Lyttelton Port of Christchurch Coal Stockyard expansion project: response to Further Information Request - Stormwater Treatment Matters

The Canterbury Regional Council has requested further information under Section 92 of the Resource Management Act, 1991.

The purpose of this report is to provide answers to those questions relating to the treatment of stormwater runoff from the coal stockyard as well as an answer to a question on the water supply to the coal yard for dust control. These are questions 19, 54, 58, 61 to 68 of the further information request, dated 10 March 2010. The report answers the questions in the order contained in the Request.

Figure 4.1: Proposed process flow diagram

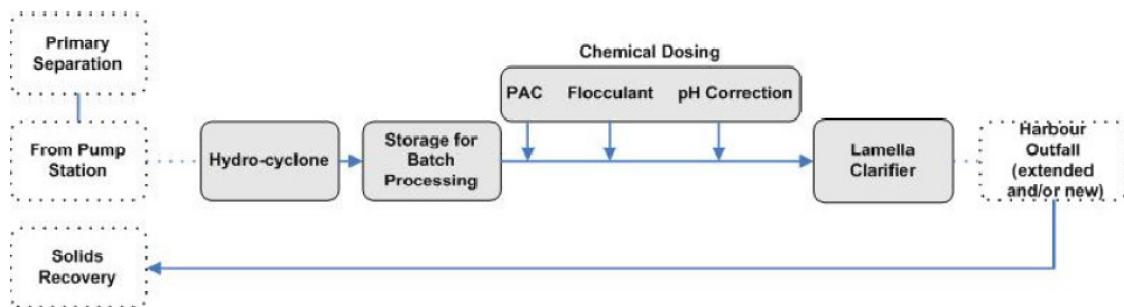
Please provide information about how coal fines will be managed and a comment on how this fits with best practice for treatment plant performance for managing coal fines.

- as per Figure 4.1: Process Flow Diagram of Proposed Treatment System in our report¹ (Pg 6) the secondary separation area will be upgraded to include the installation of a hydrocyclone, which separates fines to a level of 150 micron. The separated coal fines will be discharged into the slurry sump and pumped back into the stockyard. This additional process will ensure control over the size of coal fines that must be treated and avoids the need for personnel to handle the slurry

- the treatment process will receive the stormwater with the remainder of the coal fines. The coal fines will be utilised as a seed to improve the settling of the coagulated particles. This process is referred to as ballasted settling.

- the sludge generated in the clarifier will settle into hoppers. The proposed treatment process utilise pumps to remove the sludge from the hoppers and pump the sludge to the stockyard, where it will be distributed back into the stockpiles.
